## **ADDENDUM NO: 001**

**PROJECT NAME: ARLINGTON GATEWAY MONUMENT**

**PROJECT NO.: 1256.18**

**DATE: 07/15/2022**

**ELECTRICAL  
SITE PLAN AND  
ONE-LINE**

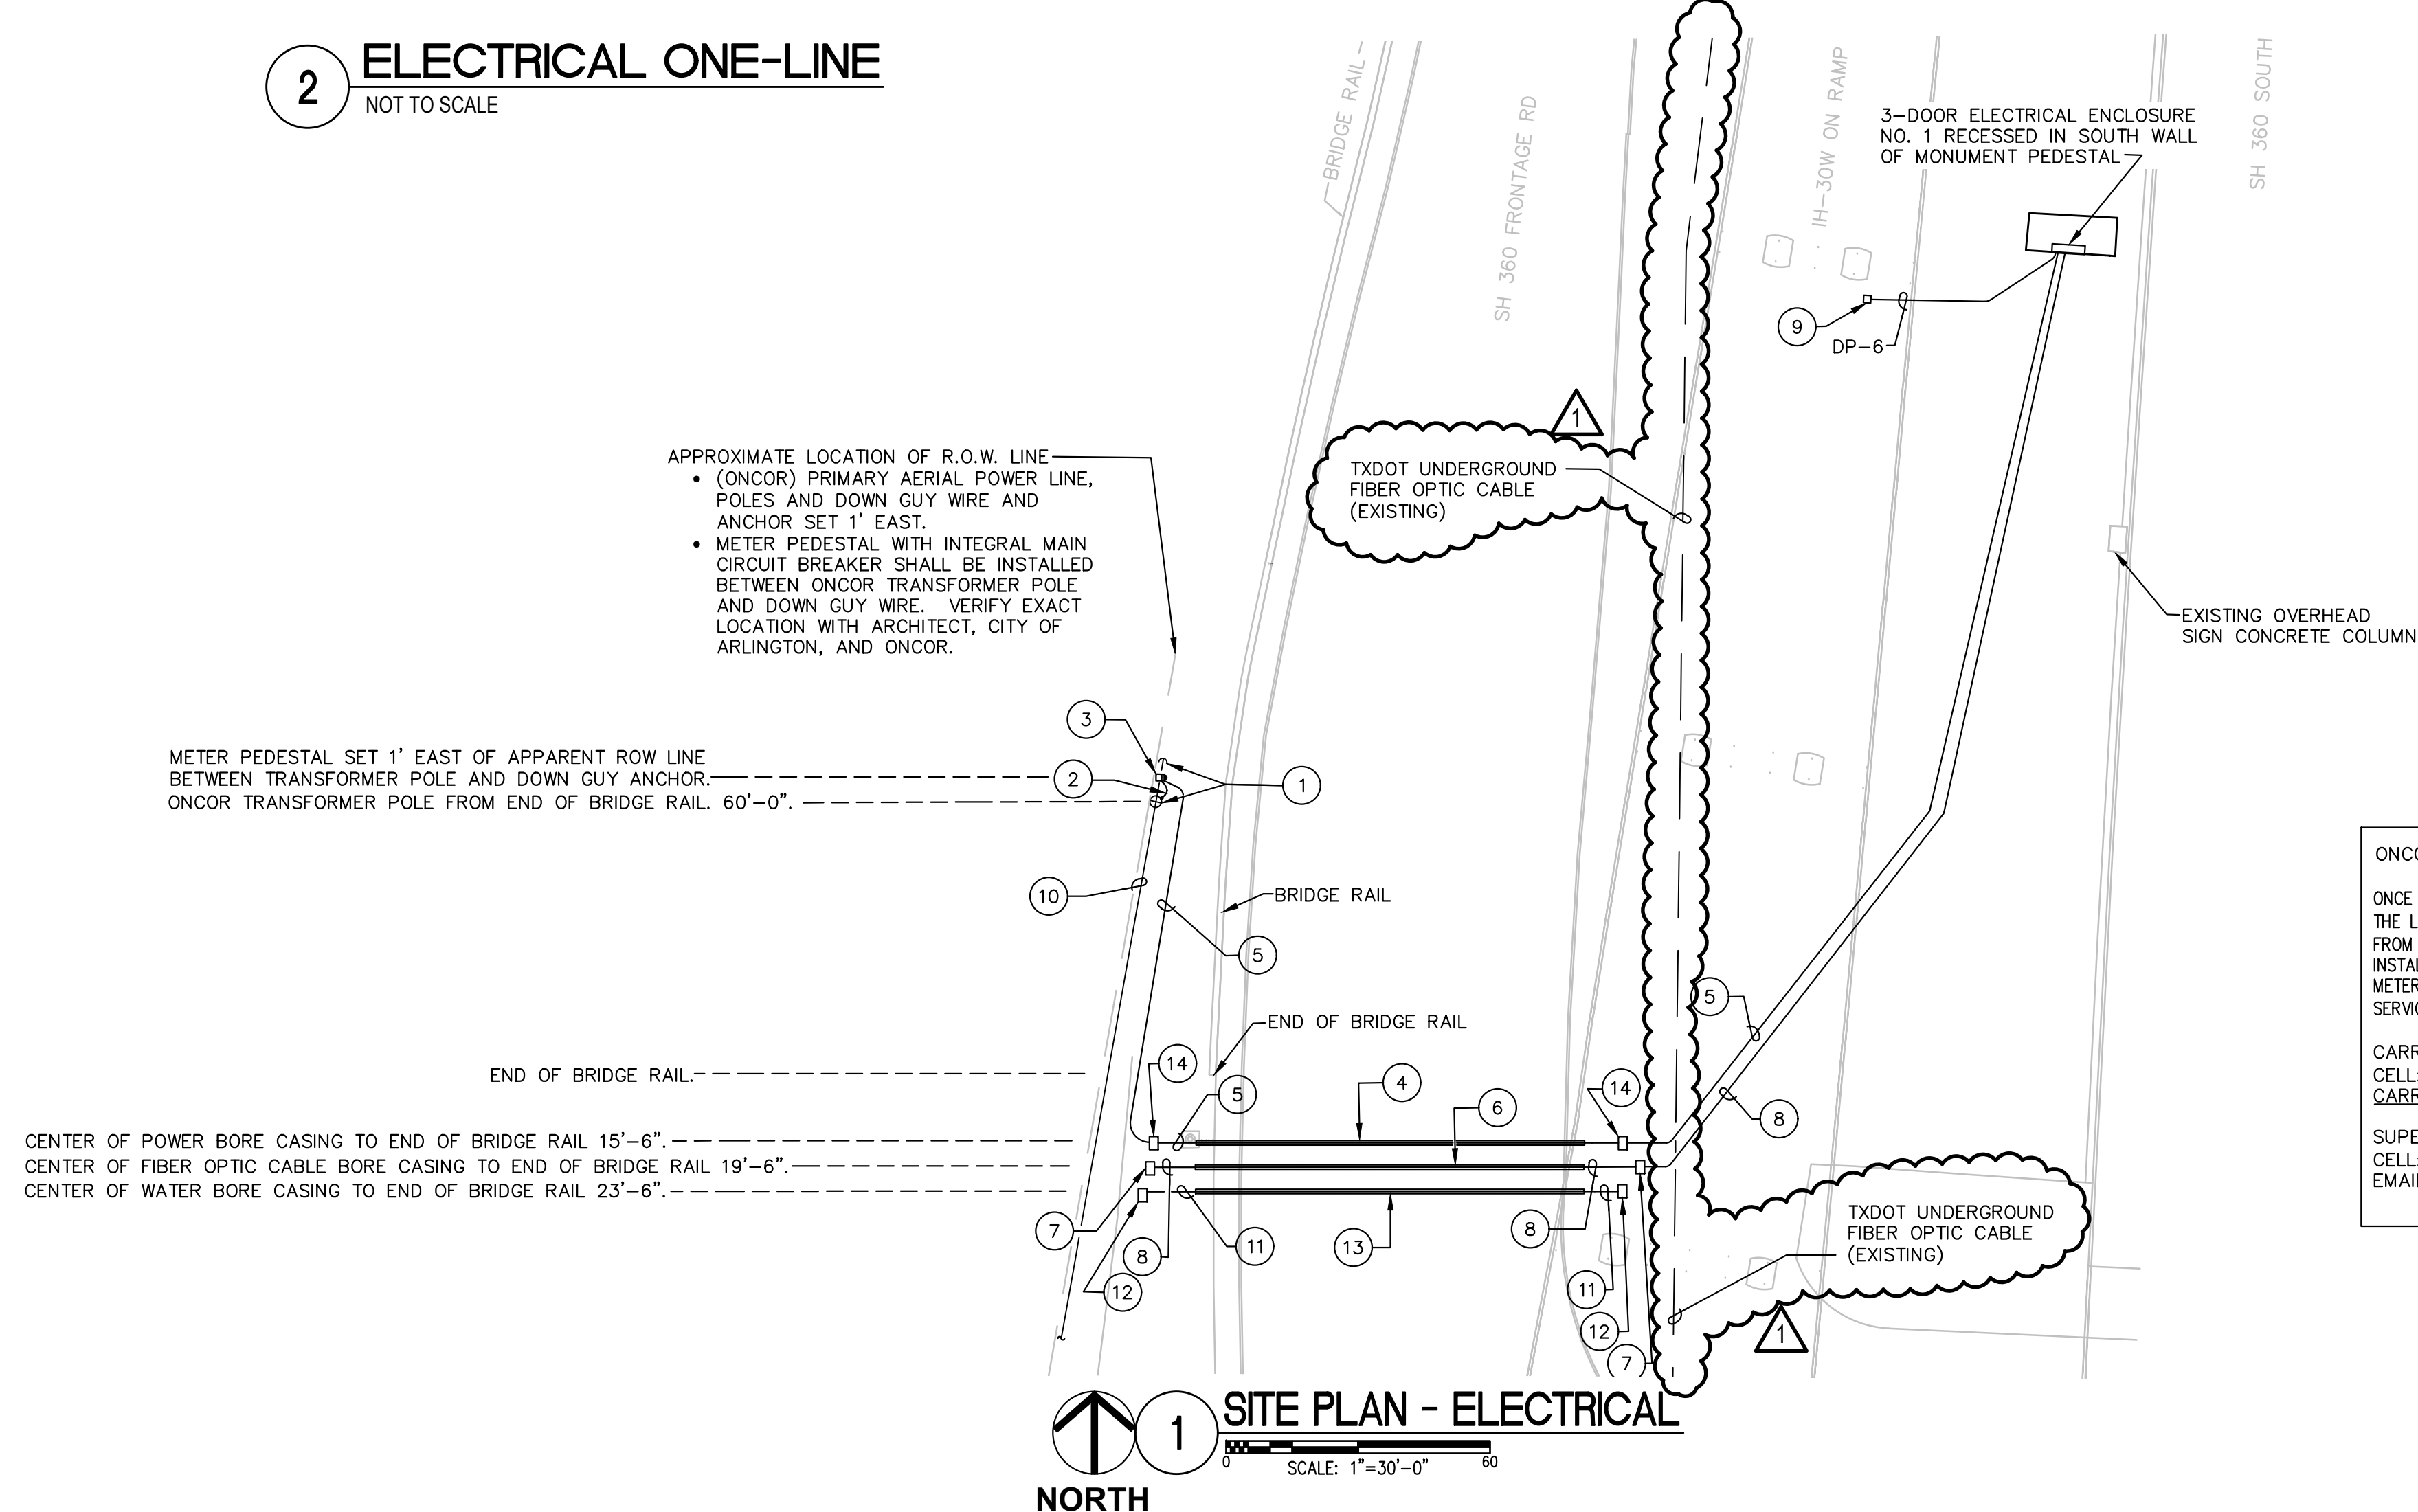
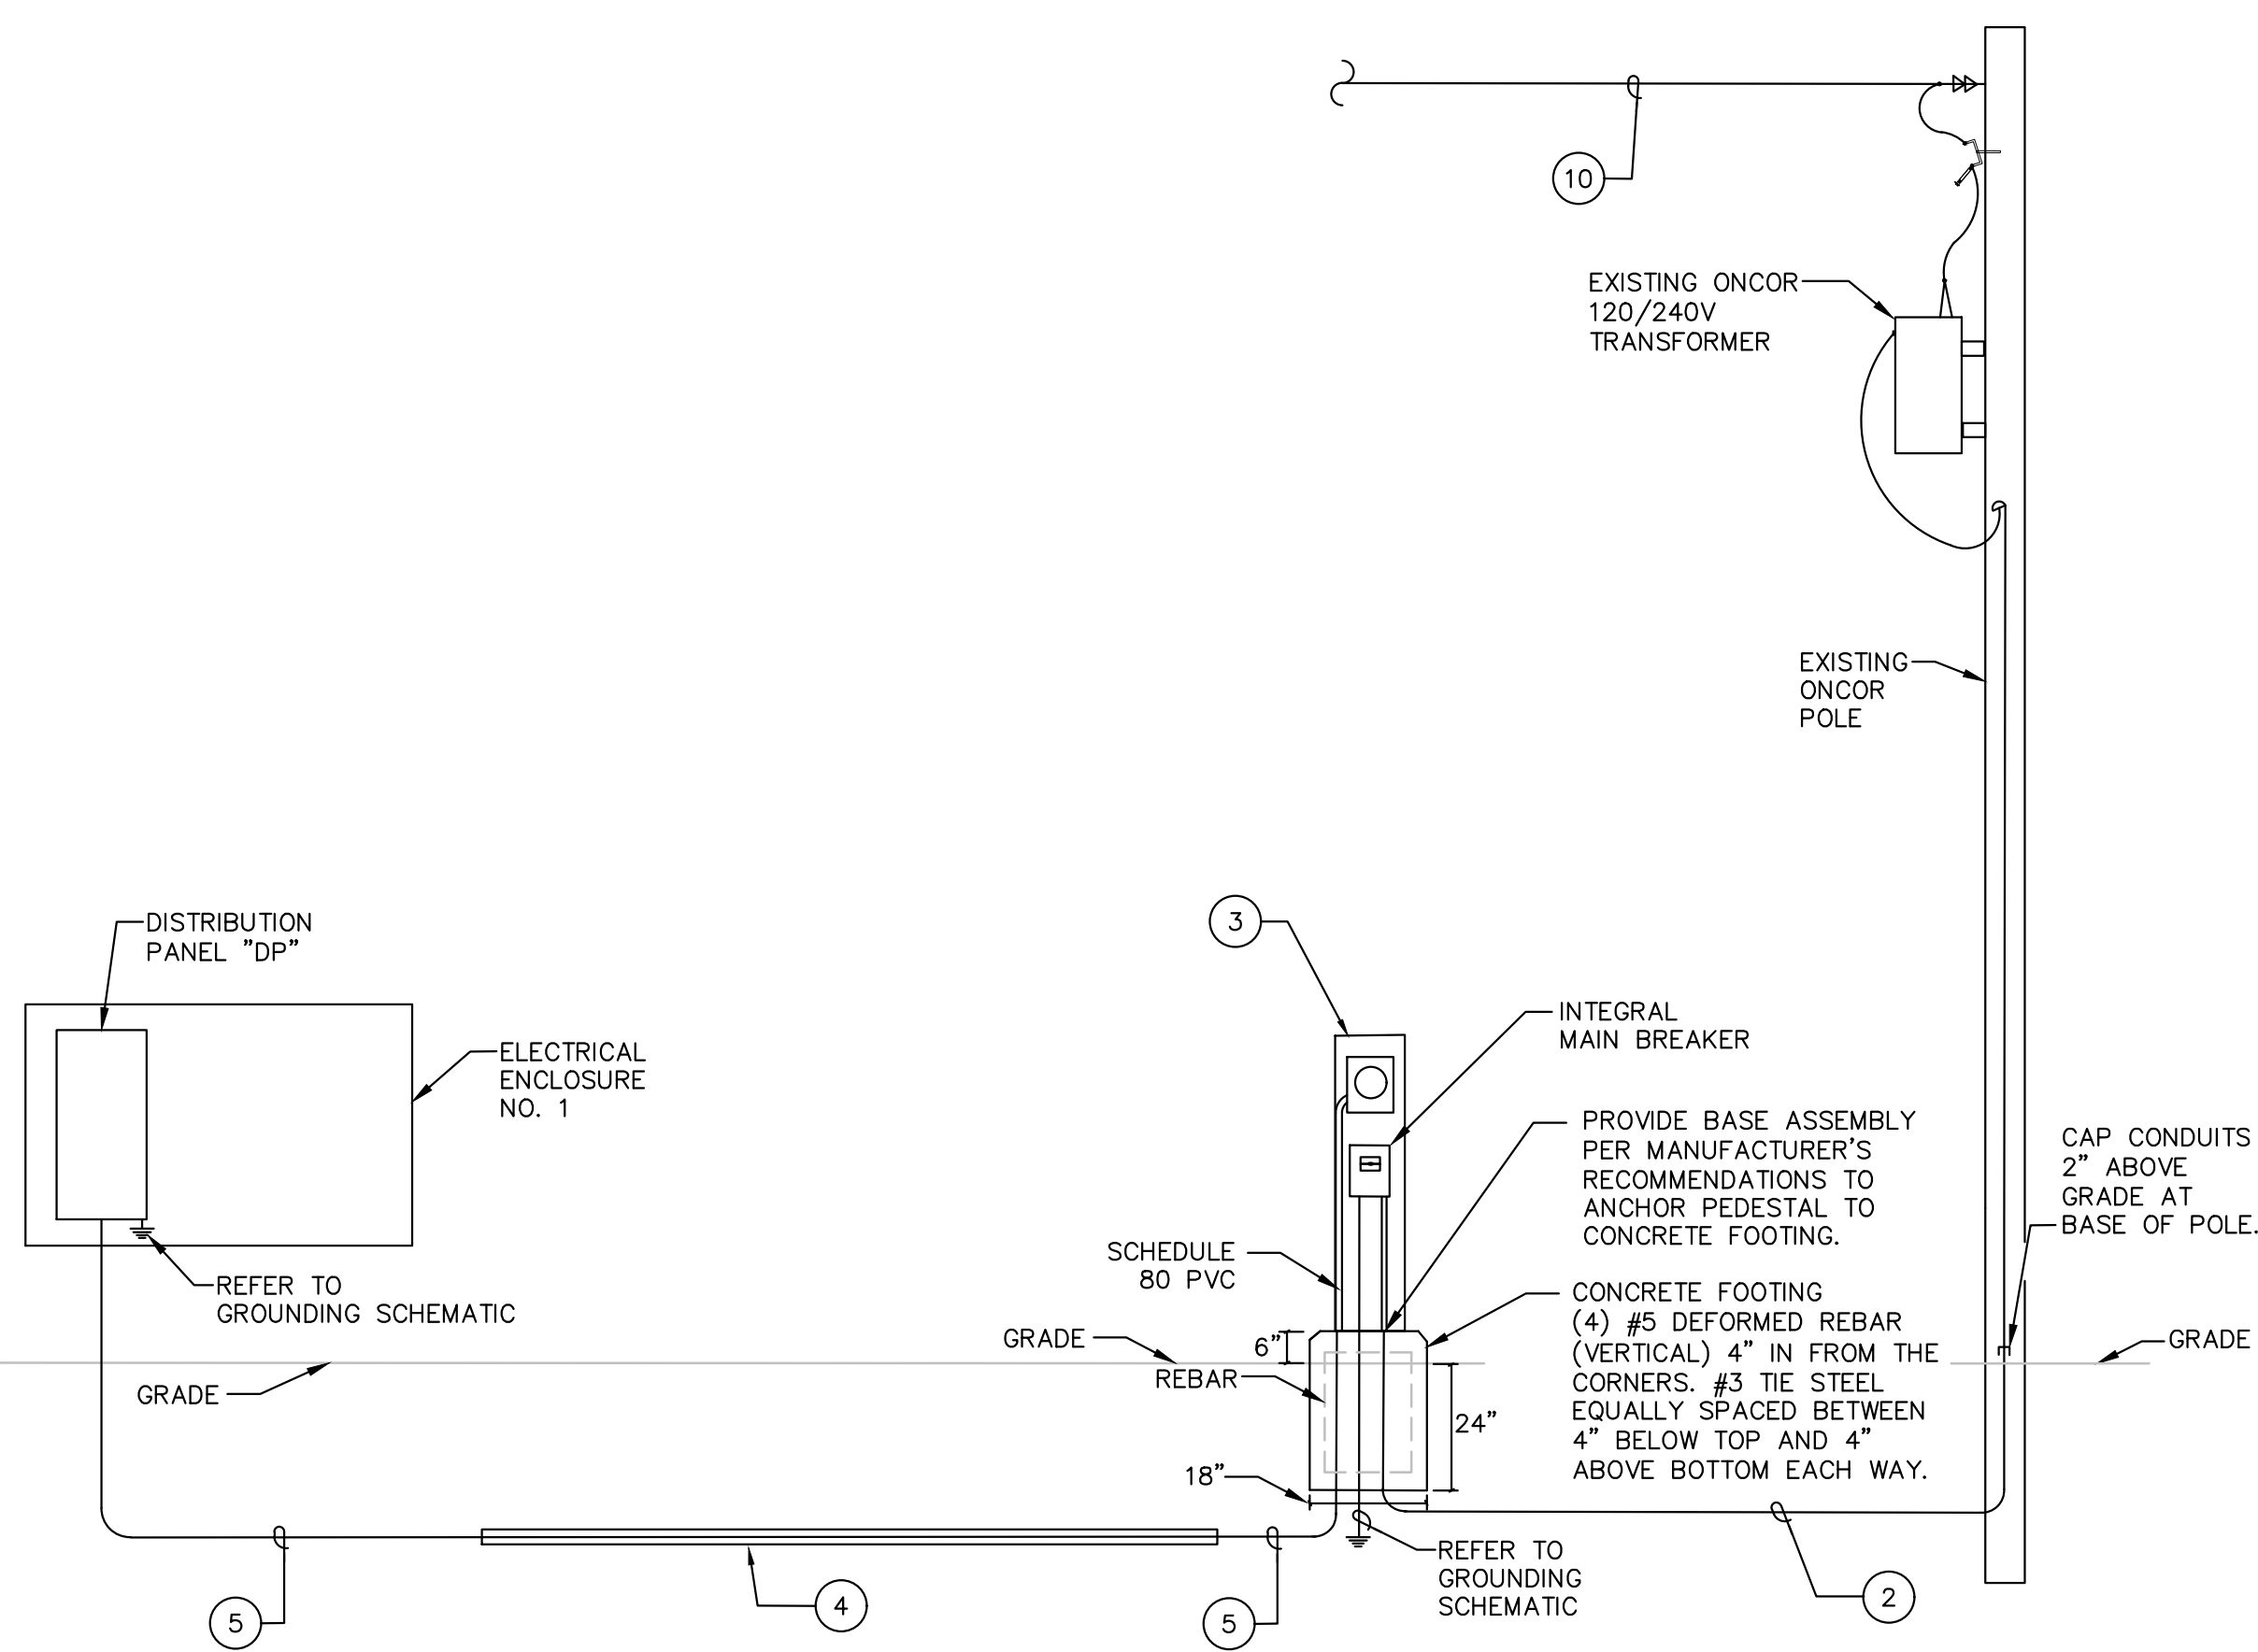
4. Sheet 16 – ELECTRICAL SITE PLAN AND ONE-LINE
  - a. Refer to revised sheet as attached to this addendum.
    - 1) Refer to attached narrative of changes provided by Yaggi Engineering.

ITEM 2: SHEET 16: Delete and substitute revised drawing, dated 07/15/2022, attached and included as a part of this addendum.

A. Add existing TXDOT underground fiber optic cable to Site Plan.
